M101.0
DN5800 BevMax 4/3/2
Package tipping & not making it in Delivery (Picker) Cup

9/14/09

Models affected: All DN5800 BevMax 4/3/2 Venders.

Picture of a bad slide that needs reworking. Both issues shown may cause tipping.

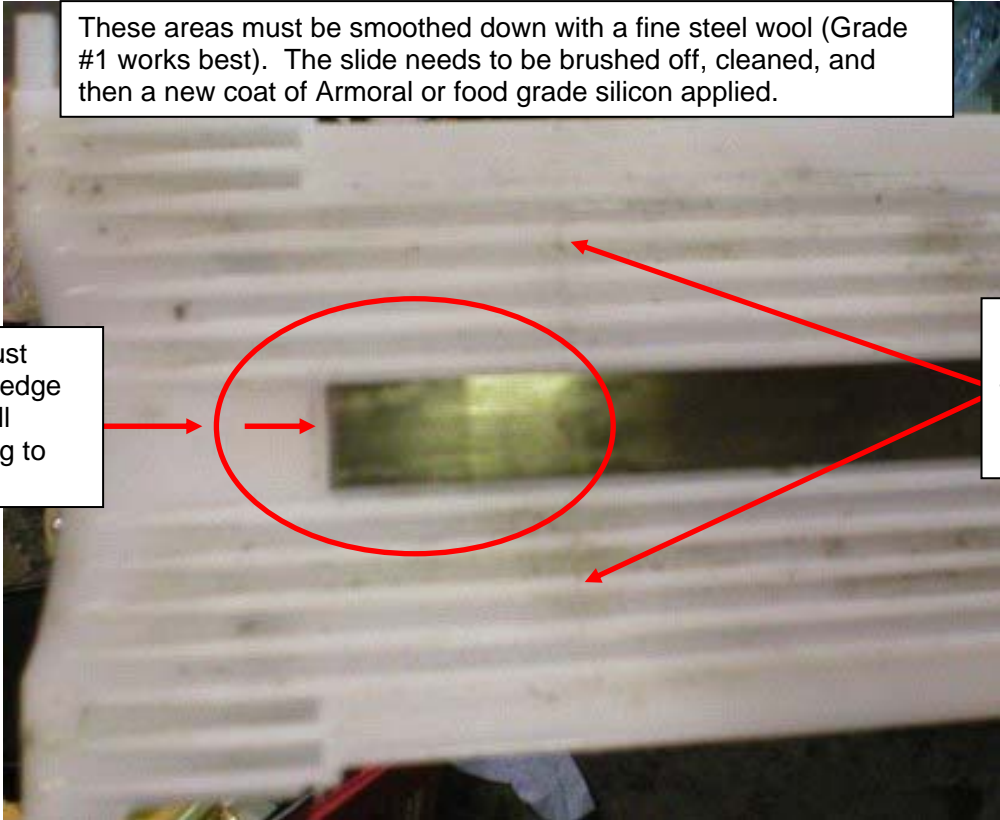
Issue: If a slide is found to have flash or a burr causing packages to tip and not make it in to the Delivery Cup.

Burrs or flash just under the front edge of the spring will cause the spring to bow upward.

Mold flashing. Note the dirt line from product rubbing.

Field Corrective Action: Areas identified with burrs or flash must be smoothed down with a fine steel wool (Grade #1 works best). The slide needs to be brushed off, cleaned, and then a new coat of Armoral or food grade silicon applied. See the following slides for views.

These areas must be smoothed down with a fine steel wool (Grade #1 works best). The slide needs to be brushed off, cleaned, and then a new coat of Armoral or food grade silicon applied.
